## CHANGE ORDER CJC North Roof Replacement

**CHANGE ORDER NO:** 02 Installment of Retrofits in place of Overflows on Side A **NTP Date:** 2/24/2025  
**DATE OF ISSUANCE:** 3/18/2025  
**Contractor:** RYCARS Construction LLC  
**Architect/ Engineer:** Alex Davila/ Dominic Calabrese

Project Name: CJC North Roof Replacement

# SECTION A - EAST ROOF PLAN

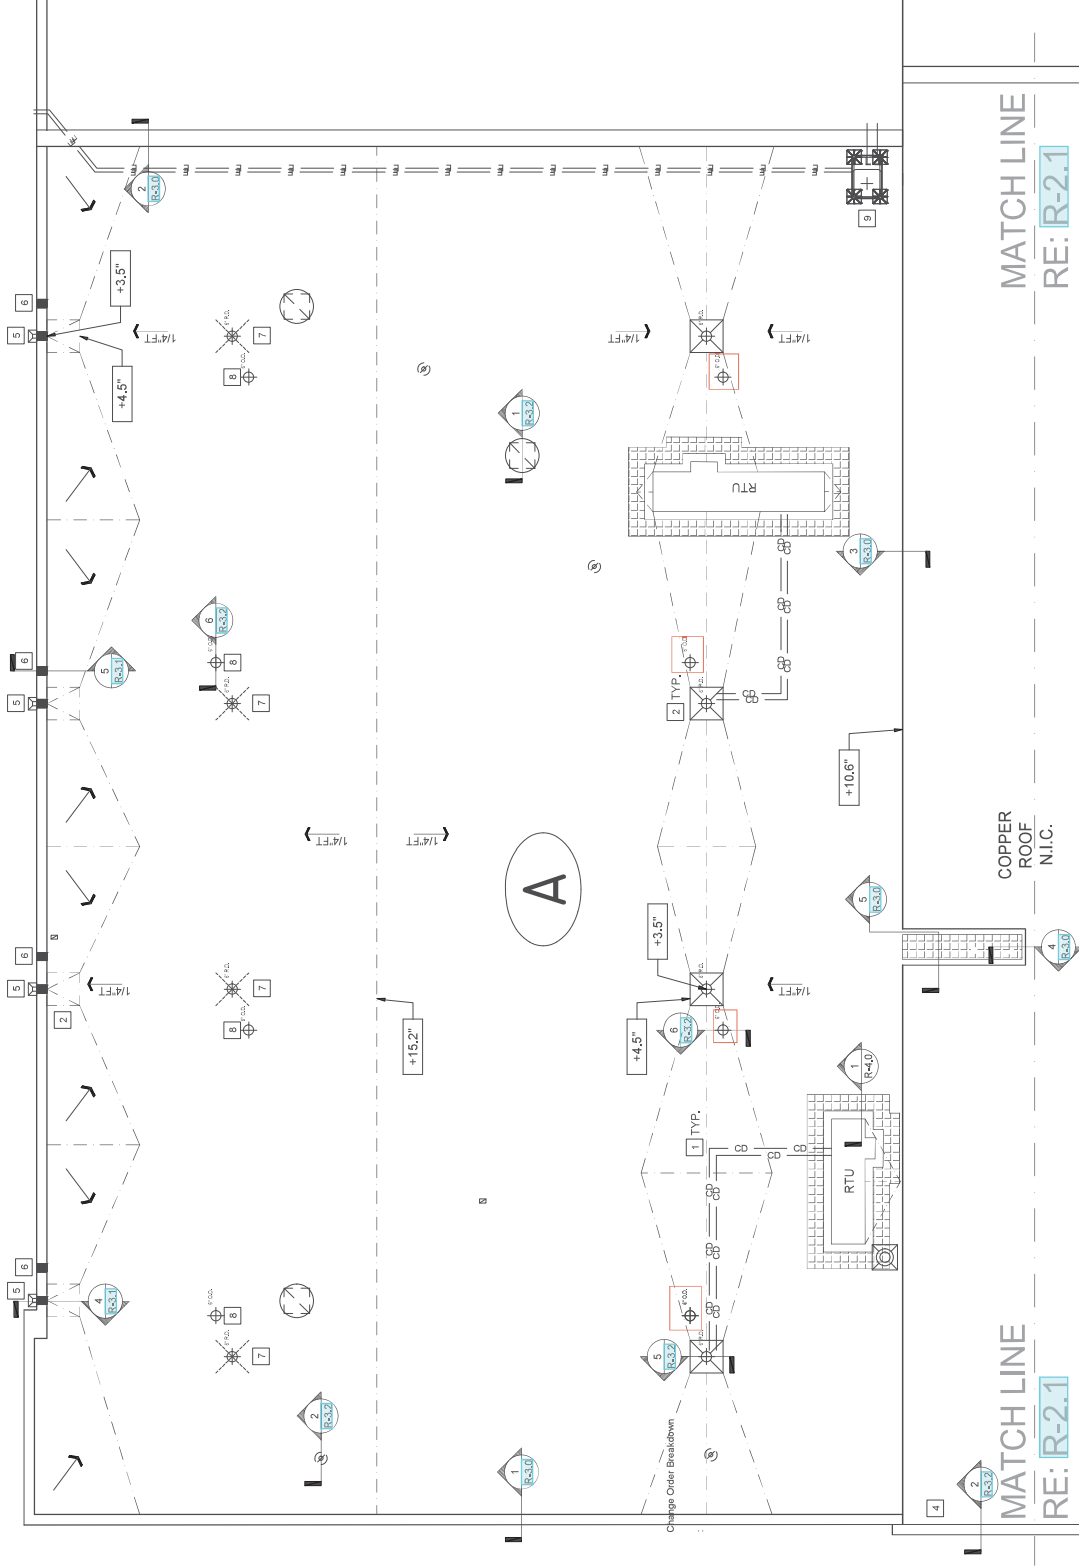
**EXPLANATION:** 1. RYCARS Construction was informed by Owner to install retrofits in place of the existing overflows on Side A of the roof due to the primary and overflow being at the same height

Installment of Retrofits in place of existing Overflows on Side A

\* Provide and install four new retrofit drains at existing overflow drains on Area A.
